## Memo

Date	12 February 2019
To	Andrea Richardson - Senior Planner
CC	Carl Hanson - Groundwater Science Manager
From	Lisa Scott - Senior Scientist: Groundwater

## Corrections to map layer '*LWRP - Aquifer Systems and Sediments*'

Figure 1: Gaps in the 'Aquifer Systems and Sediments' map layer over Christchurch City

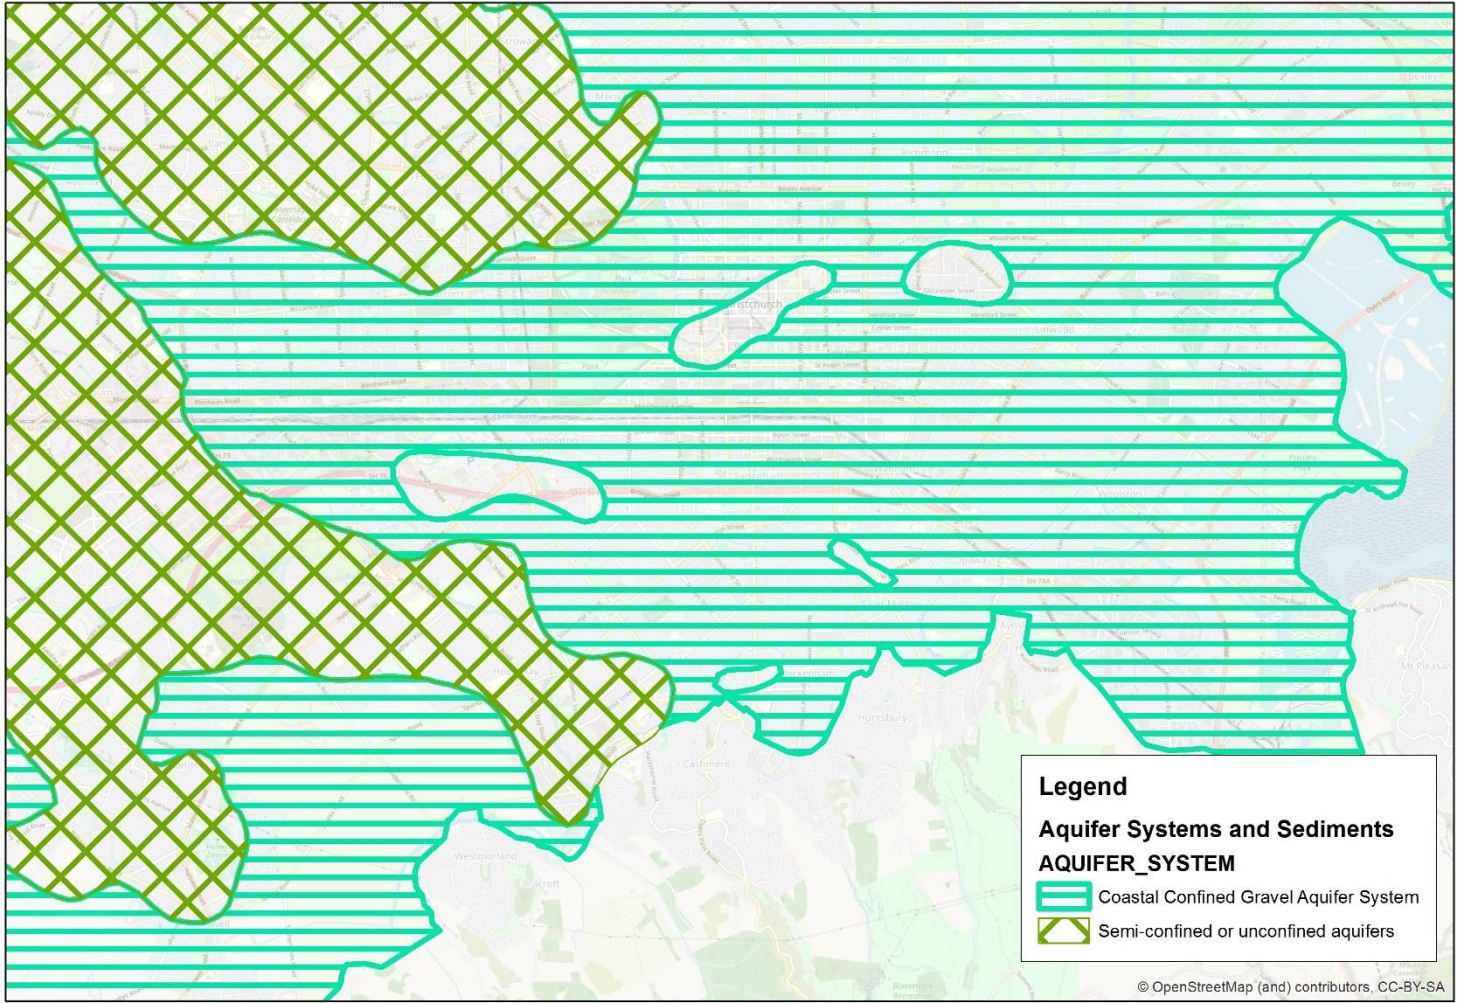
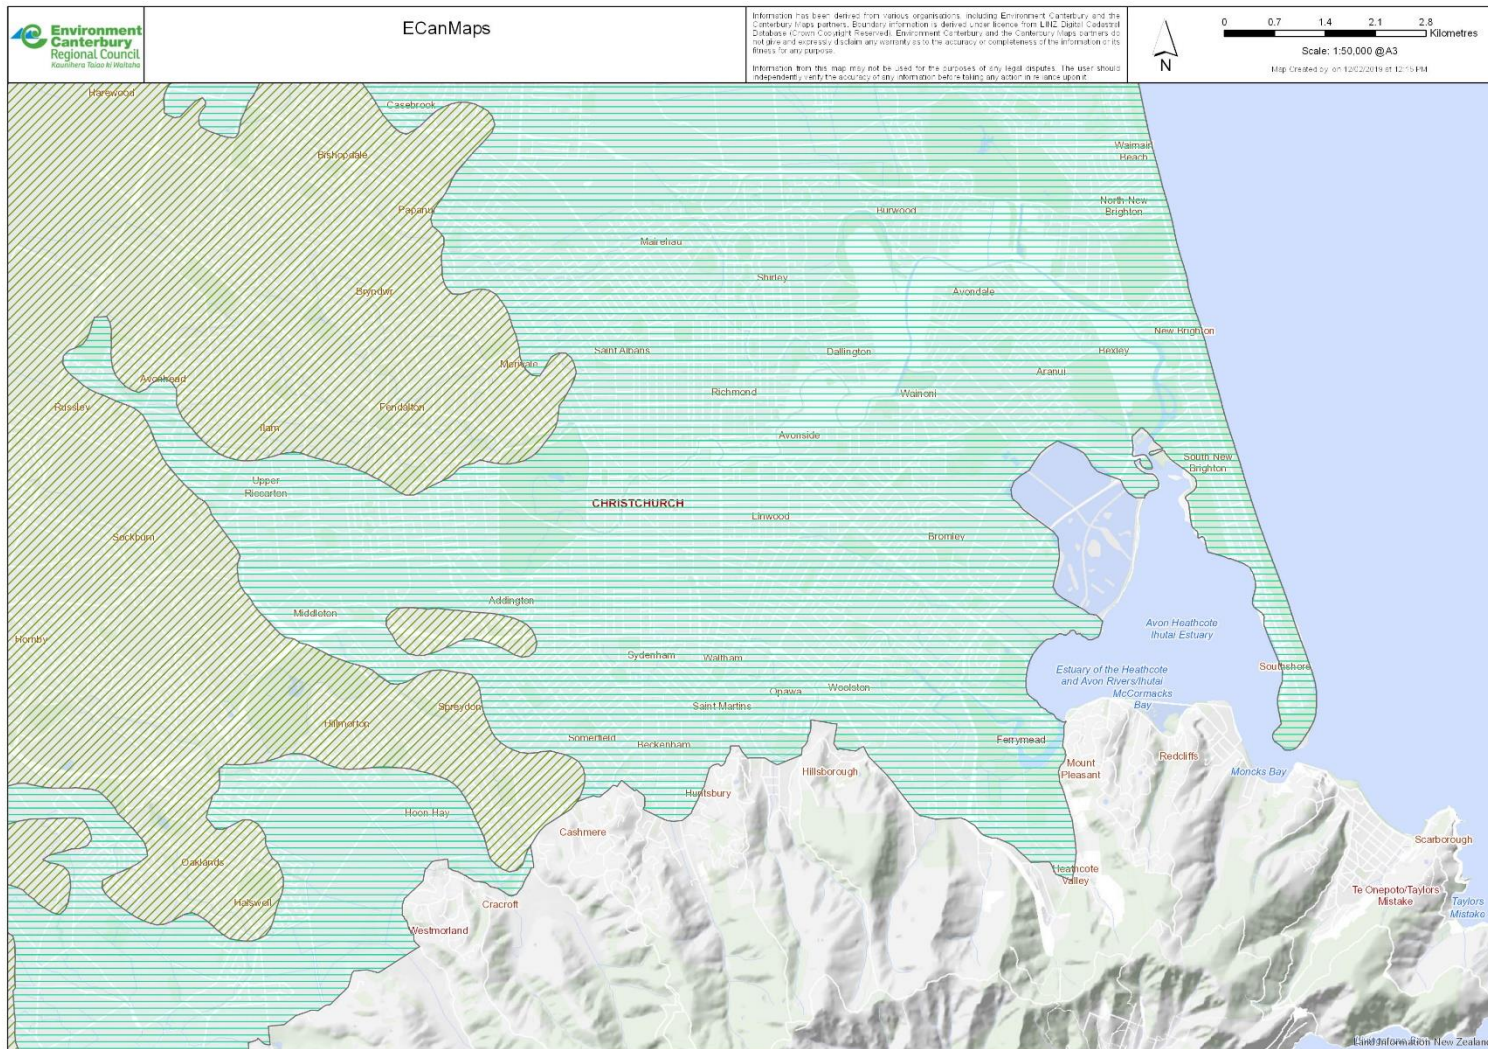
Our groundwater scientists have noticed that one of the map layers in the LWRP map volumes relating to groundwater resources may need revising. Consents planners raised the issue with us that on the '*Aquifer Systems and Sediments*' layer there are small areas within Christchurch City which are surrounded by the '*Coastal Confined Gravel Aquifer System*' but are not mapped as '*Semi-confined and Unconfined Aquifers*' or as part of the '*Coastal Confined Gravel Aquifer System*'. This has caused some confusion in applying the rules of the LWRP to activities within the unmapped areas (Figure 1). On looking at the map, it appears that the gaps in the map have arisen from an artefact of the GIS processing when combining previous datasets.

To fix the problem, I recommend that the four easternmost unmapped areas be merged with the '*Coastal Confined Gravel Aquifer System*'. The westernmost unmapped area should be designated '*Semi-confined and Unconfined Aquifer*' because of the thinner surficial fine-grained sediments and potential downward hydraulic gradients in the Lincoln Road area. I have asked the ECan GIS team to prepare a revised layer with these changes for the Omnibus Plan Change 2019.
